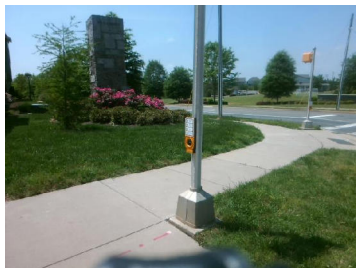
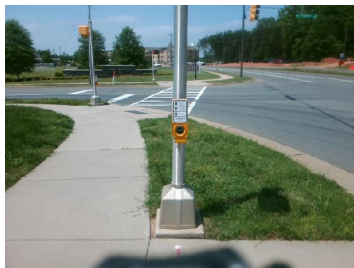
PROW/ADA: TMUTCD 4e.08, R404.2, R404.3, R406.2, R209.1, MUTCD 4e.10

MUTCD Compliance			
Yes B 1 Clear Xing Direction?	ClearlyMarked	N/A B 2 Clear Xing Direction?	N/A
B 1 Crossing Direction	To NE	B 2 Crossing Direction	N/A
Yes B 1 DistanceTo XWalk (in)	26.0	N/A B 2 DistanceTo XWalk (in)	N/A
No B 1 DistanceTo Curb (in)	88.0	N/A B 2 DistanceTo Curb (in)	N/A
Yes B 1 Diameter (in)	2.0	N/A B 2 Diameter (in)	N/A

Possible Solutions: Replace Signal Push Button With APS Button on New Post. Remove & Relocate Sign.
